**Supplementary Information from AAHK on 3RS EIA Report to ACE EIASC Secretariat
On Chinese White Dolphins, Fisheries, Air Quality, Noise, Health Impact and Methodology**

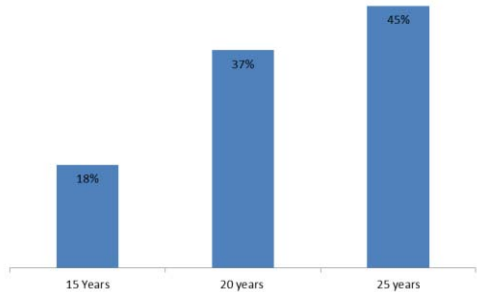
<p>➤ On Noise – noise exceedance at 60-70</p>	<p>Health impact by aircraft noise is evaluated in Section 17.3. In particular, the key health end points of annoyance and self-reported sleep disturbance are assessed in metrics of L_{den} and L_{night} respectively, rather</p>	<p>Section 17.3</p>

Request	Supplementary Information	Relevant Sections in EIA Report
<p>dB(A) in HZMB case has reckoned health impact; any comparable assessment measures done for 3RS rather than relying on the NEF calculation methodology</p>	<p>than NEF.</p> <p>To our understanding, health impact assessment related to noise was not conducted in the HZMB EIA Study.</p>	
<p>➤ Concerning table 17.3.2, while there would be a net decrease in the overall highly annoyed population, please provide geographical breakdown of the net increase in the highly annoyed population group in the 50 – 55db range and compared thereof with the net decrease in the highly</p>	<p>The HIA analysis on aircraft noise focused on comparing the changes of health impacts between the operation of 3RS and 2RS in 2030, i.e., the year of “worst operation mode”, which represented the maximum total aircraft noise emission. The assessment methodology was developed after a review of relevant practices in Hong Kong and overseas.</p> <p>As described in Section 17.3.3.12 of the EIA Report, taking into account the aircraft noise standard adopted in Hong Kong and the findings of the aircraft noise assessment presented in Section 7.3, the noise sensitive populated districts/regions located adjacent to the NEF25 contour line in year 2030 have been identified as the locations of interest and considered collectively as the assessment area for a quantitative comparison of the 3RS scenario with the 2RS scenario.</p> <p>From the established annoyance analysis, it is noted that the net increase in the highly annoyed population group in the 50-55 Lden, dB range is contributed by exposure in Tung Chung area but this is associated with a reduction of exposure population in the 55-60dB range in Tung Chung in the presence of the proposed mitigation measure of putting the south runway on standby where possible at nighttime between 2300 and 0659.</p>	<p>Section 17.3</p>
